**Subject:** SWDR - Conditions 12, 13 and 15 (Application Reference: 250213) and 5 and 6 (Application Reference: 242838)  
**Attachments:** WMHP-TG-SRWG1-SK-DD-0594-P01 - DITCH PROFILES.pdf, 4977\_Response to Consultee Comments 5 and 6\_v1.2\_20.06.2025.pdf, 4977\_LAN\_XX\_XX\_RP\_L\_1000 Written Landscape Specification P04 - Tracked.pdf, 4977\_LAN\_XX\_XX\_RP\_L\_1000 Written Landscape Specification P04.pdf, 4977\_LAN\_XX\_XX\_RP\_L\_1001\_Landscape Management Plan P05 - Tracked.pdf, 4977\_LAN\_XX\_XX\_RP\_L\_1001\_Landscape Management Plan P05.pdf, 4977\_SWDR\_Biodiversity Net Gain Report (tracked changes)\_BW\_V4-0.pdf, 4977\_SWDR\_Biodiversity Net Gain Report\_BW\_V4-0.pdf, 2025\_07\_22 EA response conds 5\_6.pdf, Environment Agency response 2025\_07\_04 conditions 12, 13 & 15 250213.pdf

Please find attached the Applicant's responses to the comments received from the Council's Landscape Officer and the Environment Agency (attached for reference) in respect of Conditions 12, 13, and 15 (application reference: 250213).

Image 2: August 2023, showing established wildflowers and headwall guardrails hidden:

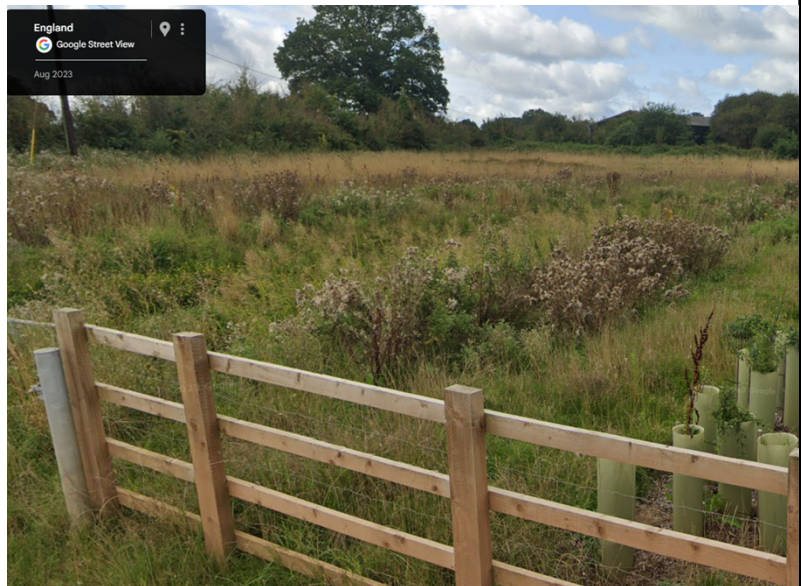
| 2.5 | Although in 6.3.112 and 6.3.113, the height and width of the berms and the slope, and monitoring at different times of year, is mentioned, there is no mention of expected water levels at each time of year. Nor is there any mention of cross sections for these berms. Additionally, the berms are very uniform all the way along. There should be variation in berm height and slope along the length of the channel.                    | <p>Refer to drawing WMHP-TG-SRWG1-SK-DD-0594 submitted under Discharge of Condition 5 (Application Reference: 242838). This drawing is attached with this response for reference.</p> <p>The water level within the diverted Luckley Brook channel is expected to vary seasonally, ranging from dry conditions to full submergence of the channel. While we understand the ecological benefits of introducing variation in bench levels, this is not being considered as part of the current design. The principal of the channel remains on maintaining consistent conveyance and hydraulic performance within the channel, in consistency with the full planning application (reference: 192928). It is also understood this variation will generate naturally over time through the deposition of sediment.</p> <p>A similar arrangement has been approved and implemented at Eastern Gateway, Waterloo Road, Wokingham (upstream of the Emm Brook), which shows fast establishment of wildflowers that contribute to creation of variation in the ditch profile from the engineered design:</p> |

Image 1: May 2023, showing where the headwall guardrails are clearly visible.

Image 3: August 2023, showing established ditch vegetation in short period of time giving variation to profile:
